Docket Item #7 A & B

DEV. SPECIAL USE PERMIT #2007-0005(A)  
SPECIAL USE PERMIT (TMP) #2007-0051(B)  
THE MADISON

Planning Commission Meeting  
January 3, 2008

**REQUEST:** Consideration of a request for approval of a development special use permit with site plan for a residential/retail mixed use building with underground parking; increased floor area; a parking reduction; a transportation management plan; and modifications.

Figure 12. Bulk plane requirements.

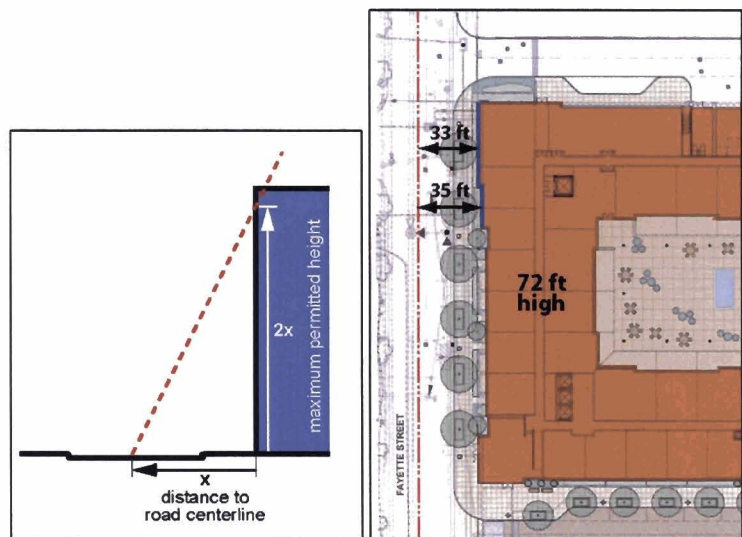
Although the CRMU-H zone does not have yard requirements, the Zoning Ordinance requires that the building be set back from the centerline of the street it faces a distance equal to at least half the height of the building at every point. The intent of this bulk plane/setback provision was to ensure an appropriate distance between buildings on each side of the street. At the northwest corner of the site along Fayette Street, the portion of the building that does not meet the setback requirements is 72 feet tall with a 33- to 35-ft. setback from the centerline. This setback rule requires a minimum 36-ft. setback from the centerline of Fayette Street, and therefore, the portion of the building in this location either needs to be pulled back 1-3 feet or be lowered.

**Recreation, Parks & Cultural Activities (RP&CA):**

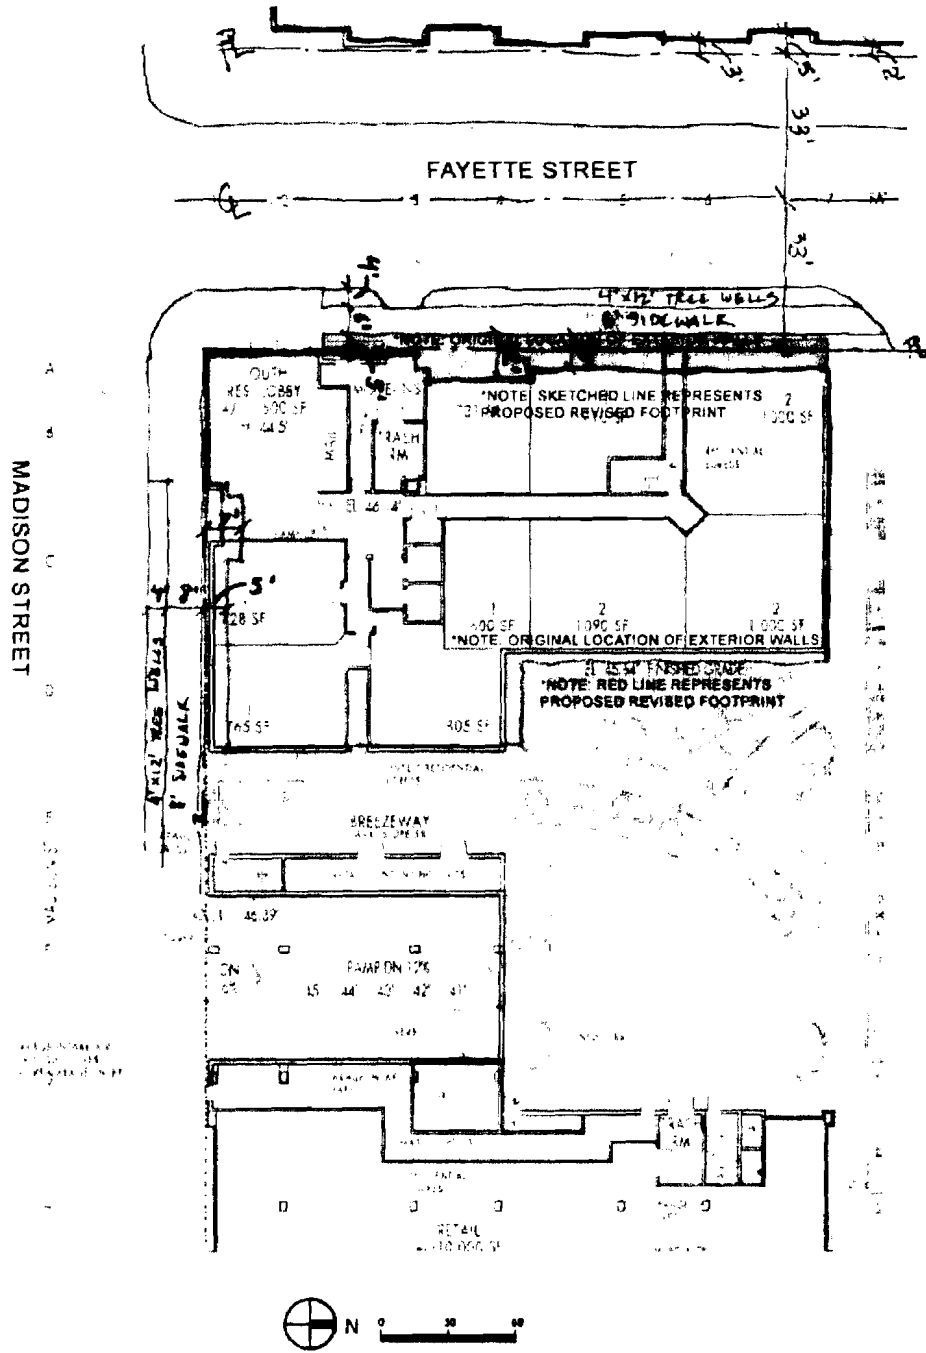
- R-1 Clarify specification of *Cercis canadensis* as single or multi-trunk.
- R-2 Clarify specification of *Lagestroemia indica* as single or multi-trunk.
- R-3 Clarify specification of *Magnolia virginiana* as single or multi-trunk and if applicable, provide cultivar.
- F-1 Remedy misspelling of *Ilex crenata*.

Fig. 7 Front yards proposed along Fayette St.

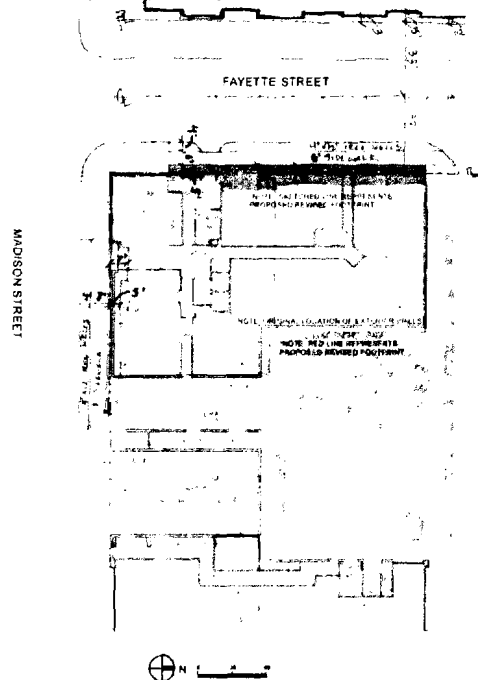
Similar to the approach in Eisenhower East, staff is recommending that the applicant provide ground level open space on-site but also contribute to an open space fund for the Braddock area that would enable the purchase of a useable consolidated park. Staff is also recommending additional front yards and areas for landscaping on Fayette Street. (Fig. 7)
